# The Light company

March 11, 1986  
ST-HL-AE-1621  
File No.: G9.17

South Texas Project  
Units 1 and 2  
Docket Nos. STN 50-498, STN 50-499  
Auxiliary Feedwater Requirements

Attached for your information and use is a copy of revised sections of the STP FSAR as transmitted to the NRC staff in Washington on March 6, 1986. These revised sections reflect the commitments as outlined in the referenced letter.

Figure 10 A-12

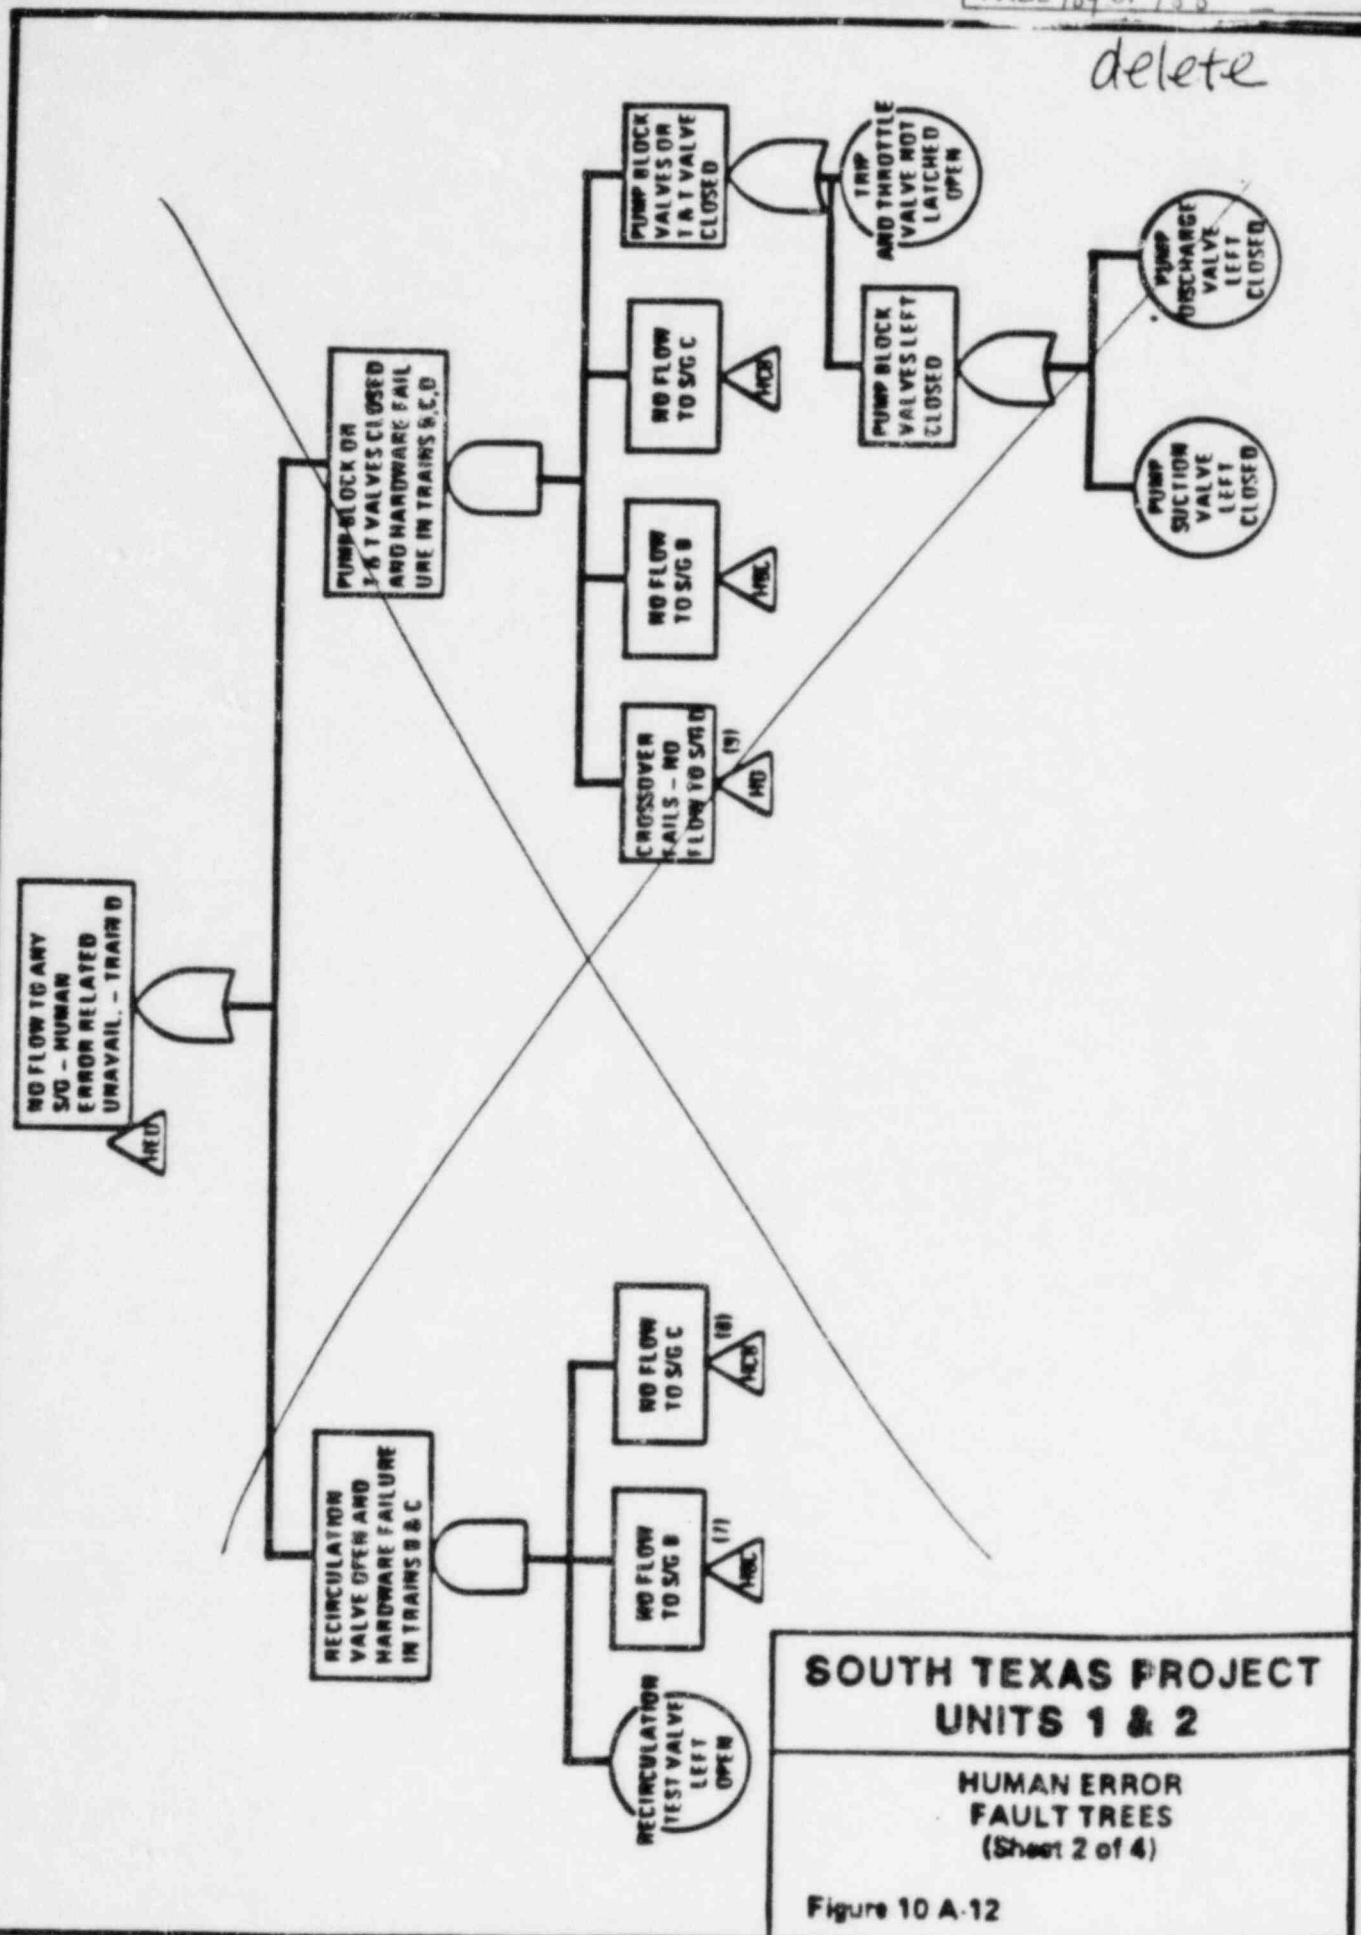
delete

Figure 10 A-13

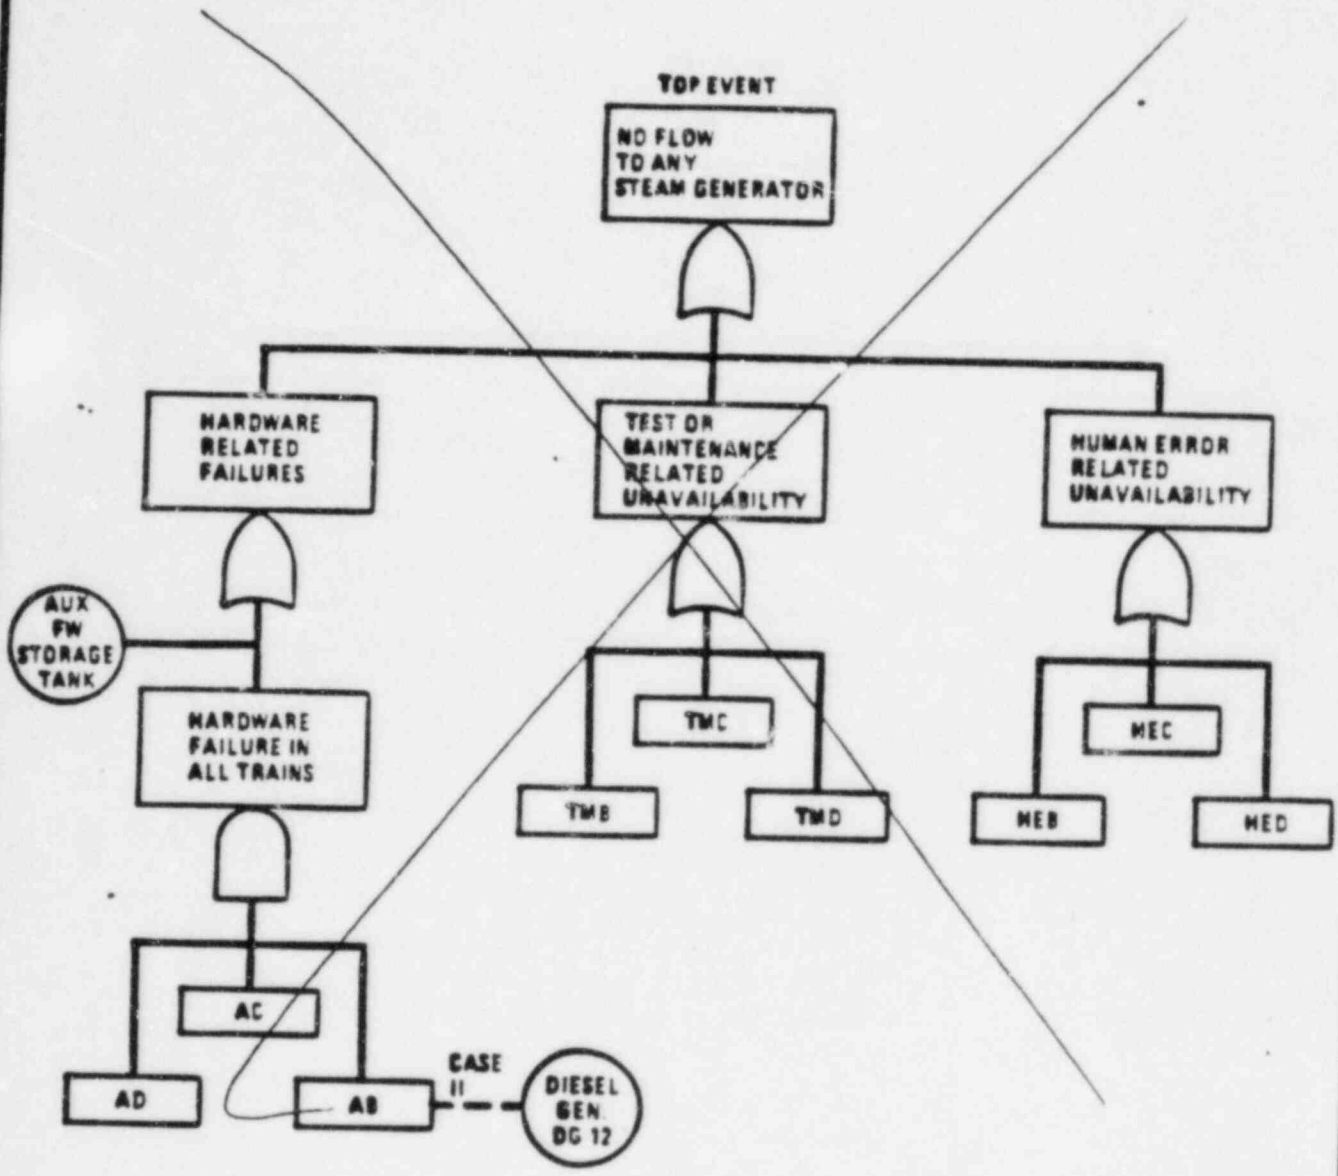
*delete*
